## 7864048 – Block C, Bracknell Gate, Frognal Lane, London NW3

I refer to your email regarding the balcony for Block C at Bracknell Gate. The existing planning permission is for the replacement of the existing balcony with the new one as the old one is in need of replacing.

Figure 1 – Failure of the Lintel

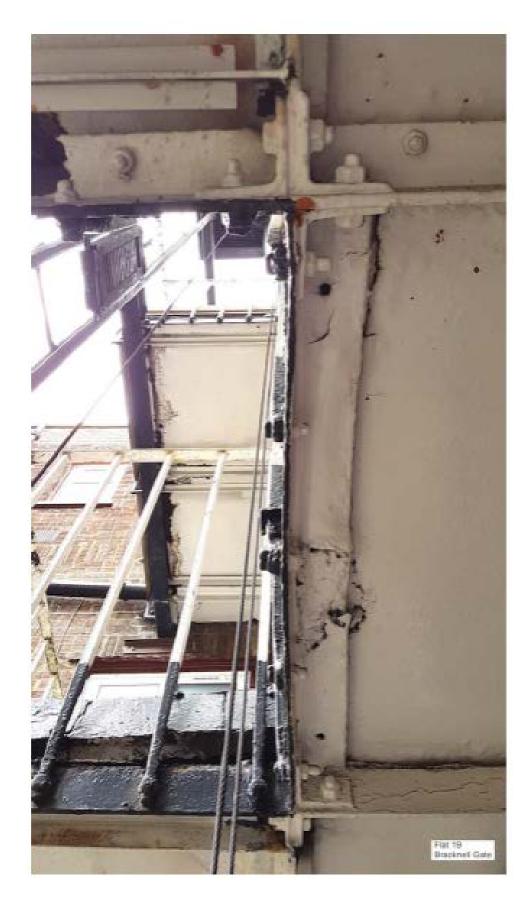
The existing balcony beam rests over the windows at ground, first and second floors. We do not know the capacity of the existing lintels over the windows, which are likely to be reinforced concrete lintels. As can be seen from the appended report, two of the lintels have already failed due to the existing arrangement.

As we are replacing the balconies, and as we are not able to determine what reinforcement is in the reinforced concrete lintels, I cannot be satisfied that the reinforced concrete lintel is capable of supporting the load from the balcony and therefore may fail in the near future. I would strongly suggest that the size of the balcony is increased so that the beam supporting the balcony sits on the pier between the windows.
